**E8364B-07****S E R V I C E N O T E**Supersedes:  
NONE**E8364B PNA Series RF Network Analyzers****Serial Numbers: MY00000000 - MY43040911****Add-on mechanical components to enhance instrument reliability****To Be Performed By: Agilent-Qualified Personnel or Customer with specific product repair knowledge – requires instrument disassembly and component replacement.****Parts Required:**

Further design review has suggested the addition of a clamping mechanism to ensure that the 8121-0118 ribbon cable can not vibrate loose from the Test Set Motherboard connector during extreme handling.

McMaster Carr item 6959A18 (T-10 torx size L-key)

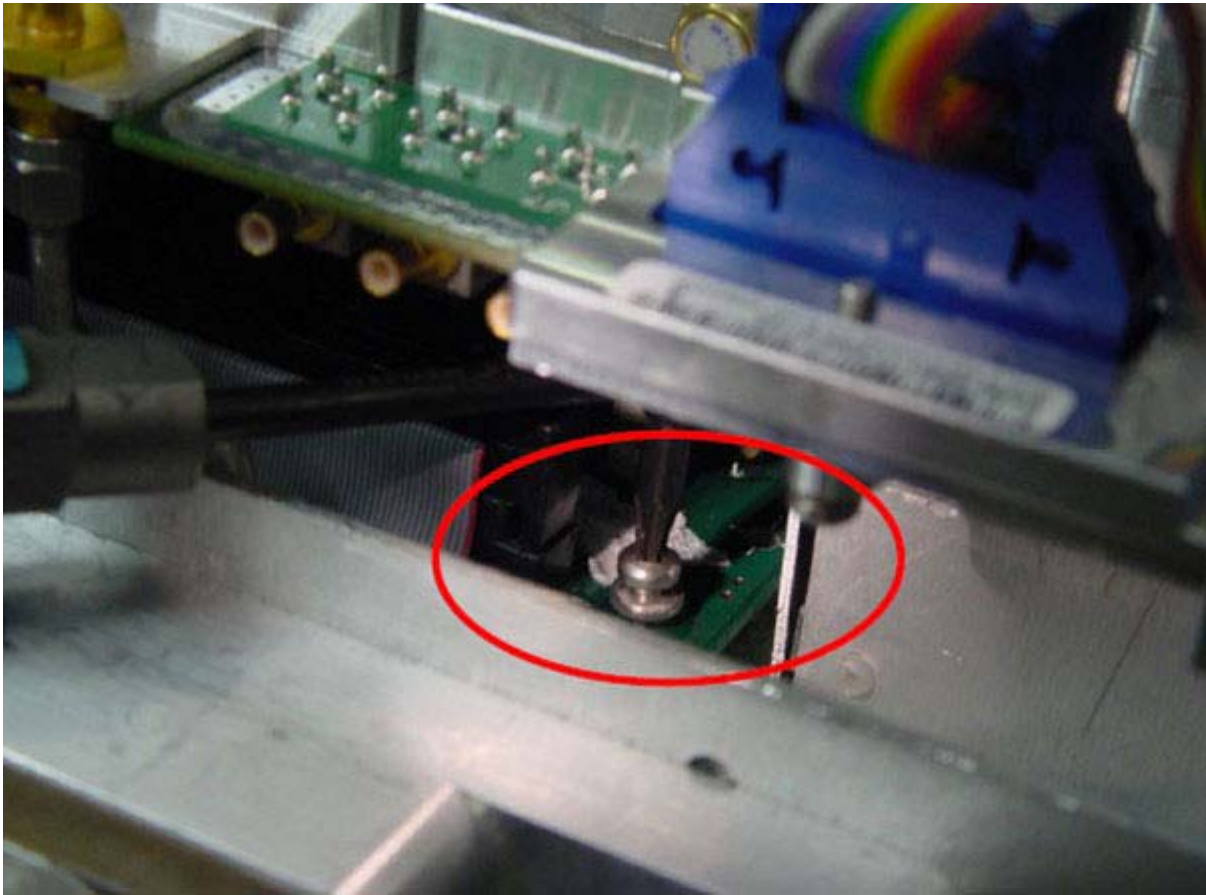
- b. Remove the open end head by loosening set screw. It will be replaced with L-Key shown below.

- c. Secure and orient the L-Key to the breakaway handle

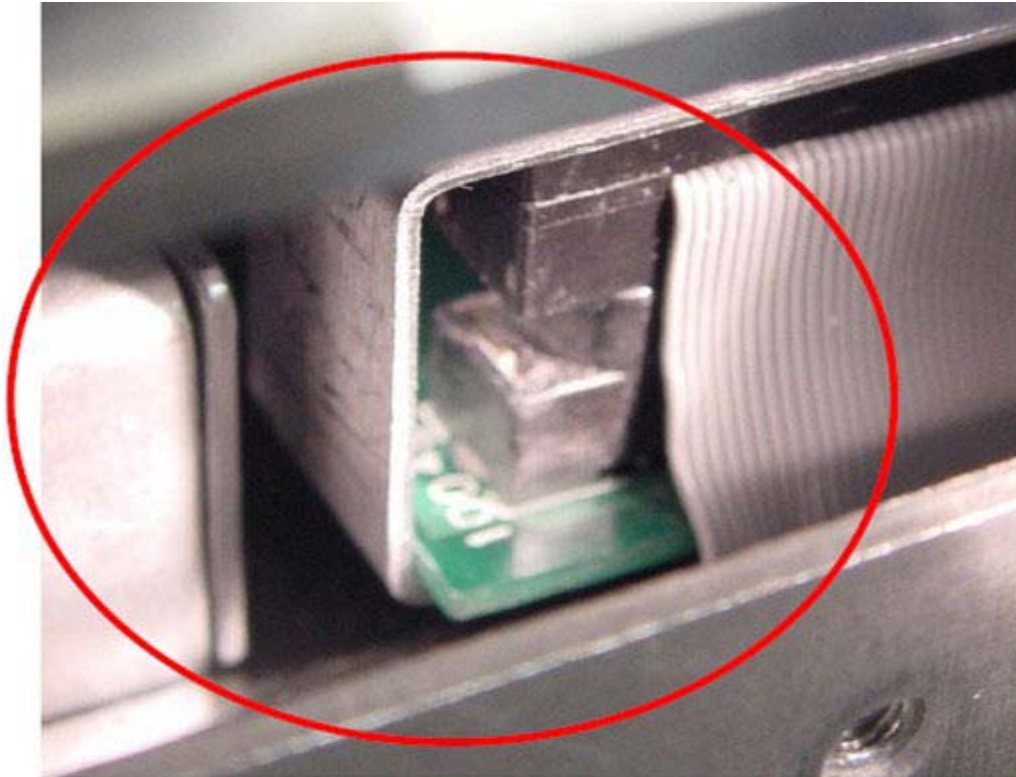
- a. Remove and discard existing screw near ribbon cable connector on System Motherboard. See below.

- b. Insert Ribbon Cable Clamp under Source Assembly as shown.

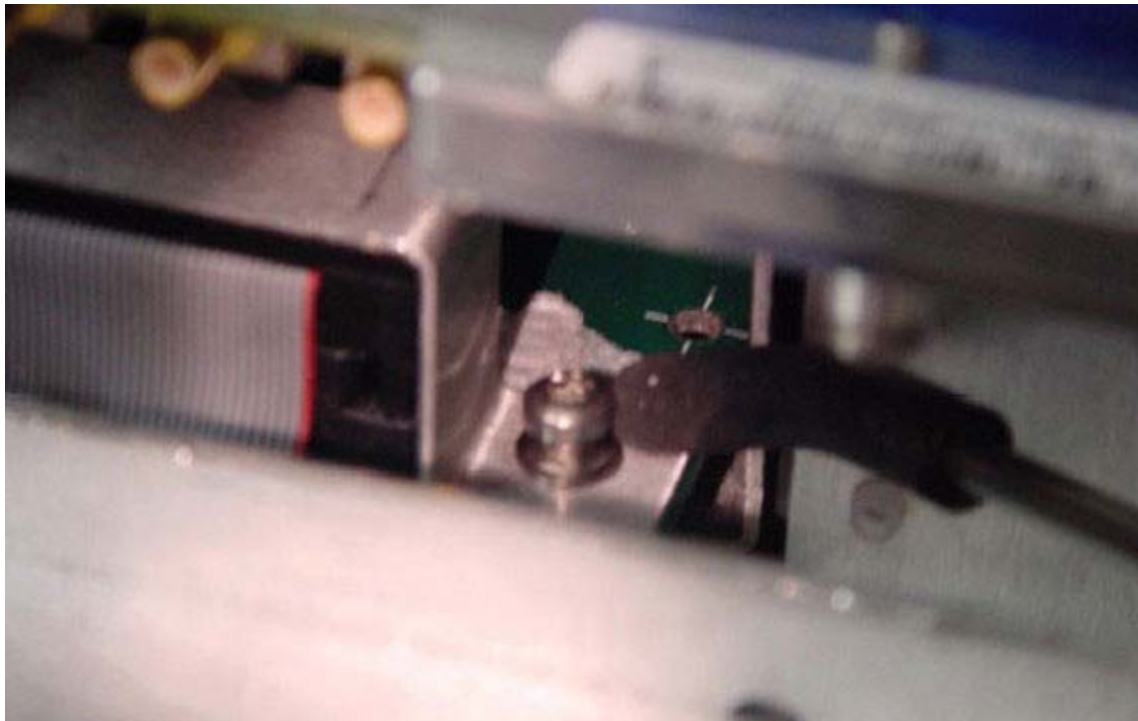
- c. Position the clamp over the Ribbon Connector. Use needle nose pliers if necessary to slide the clamp into place. Ensure that the edge of the clamp is parallel to the connector and not skewed.

**NOTE:** Ensure that the Clamp Lip is secured **BELOW** the edge of the System Motherboard

- d. Using tweezers, install a new 0515-0374 screw through the hole in the bracket.

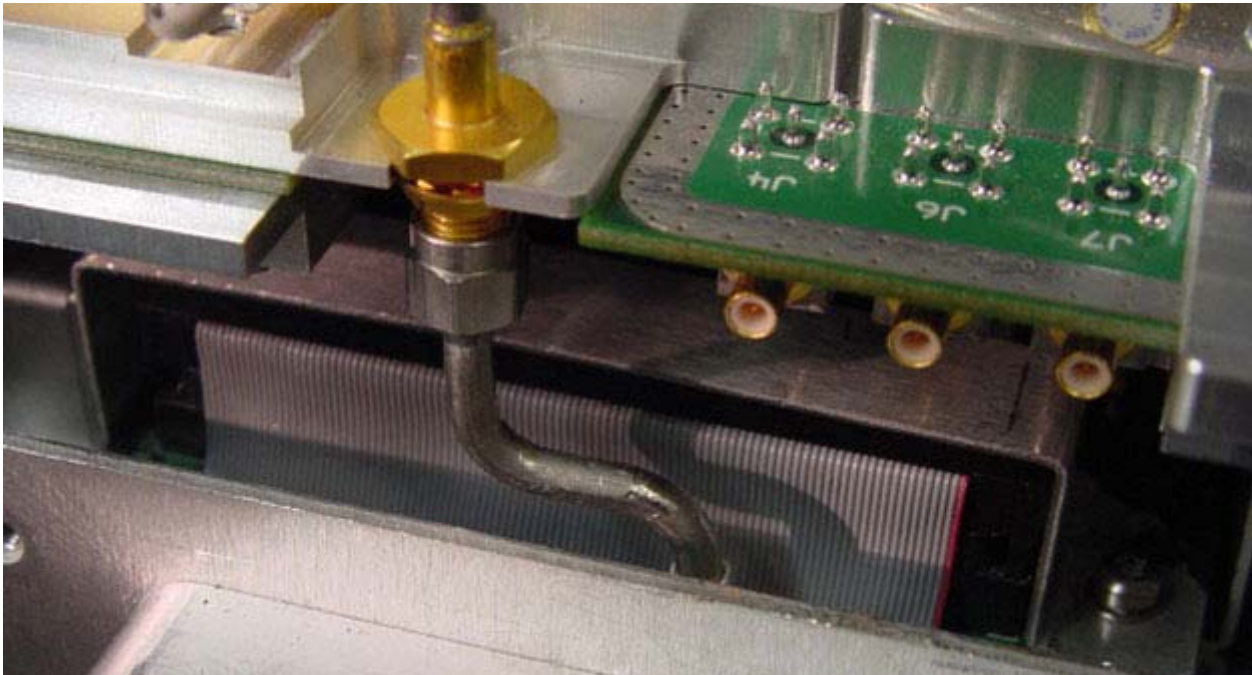
- e. Use a nut runner tool (T-316130) or alternatively a clean erasure end of a pencil to help run the screw.

- f. Secure screw using the modified 10 lb-in breakaway wrench.

- g. This image shows the final position of the secured clamp.

Figure 2a

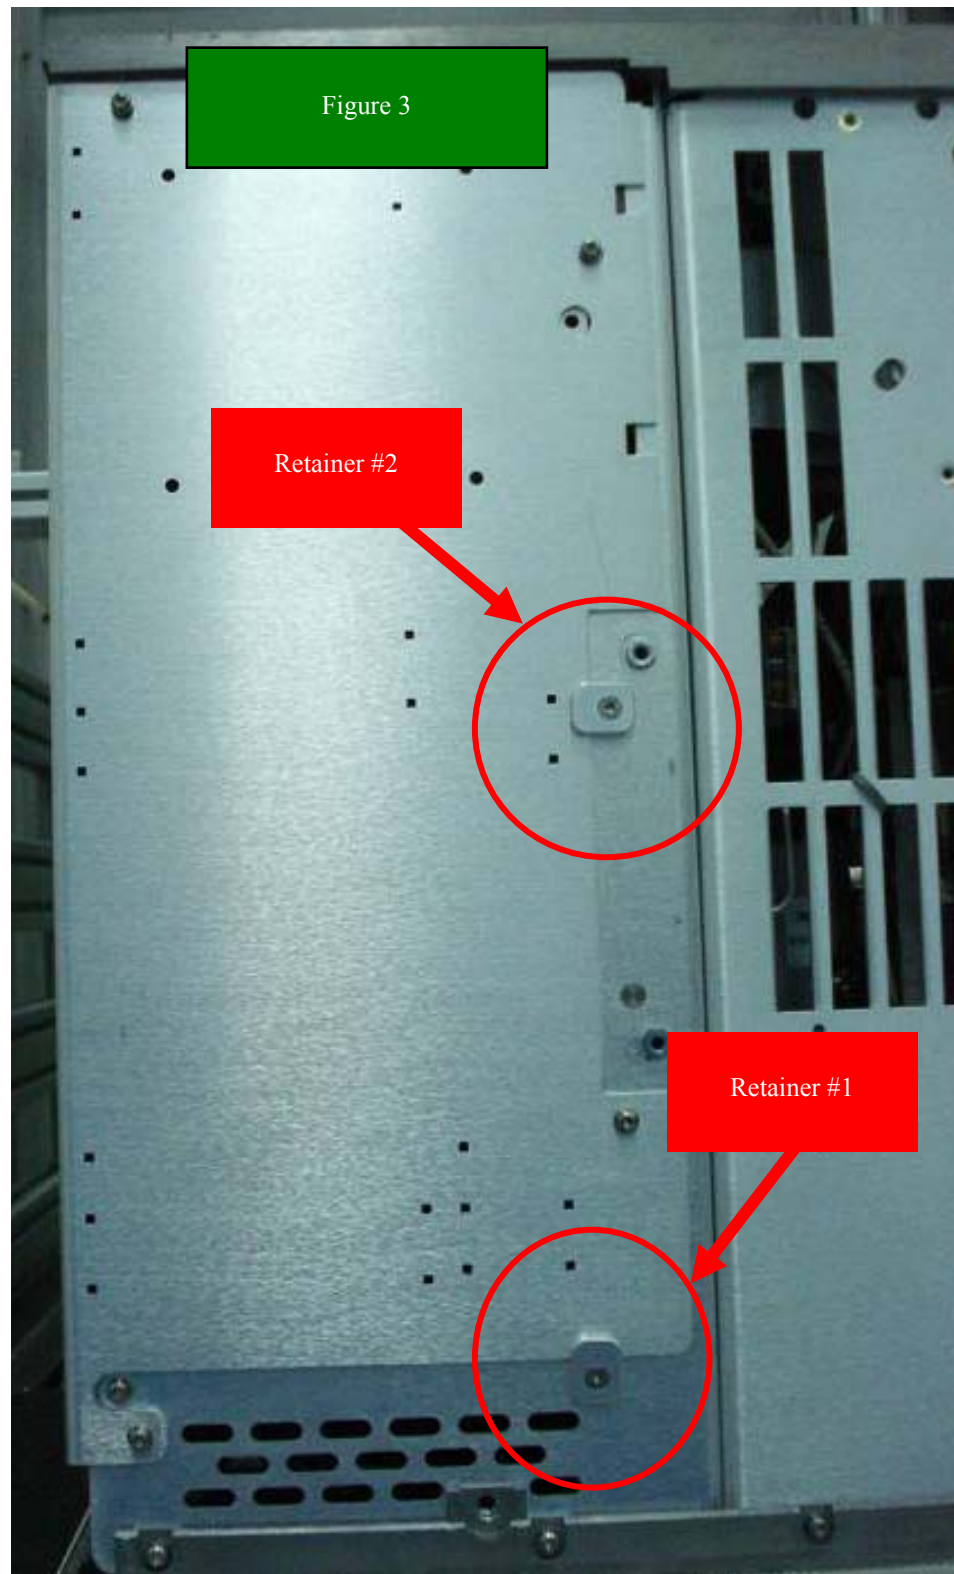
The Clip Retainer (E8361-20067) to be secured with Flat Head screw (0515-1644) in 2 places at 9 lb-in. This Retainer Clip may naturally rotate a bit when being secured, which is acceptable. Note that the existing screw needs to be removed and discarded prior installing Retainer Clip #1 (shown below in Figure 2a, 2b, and 3).
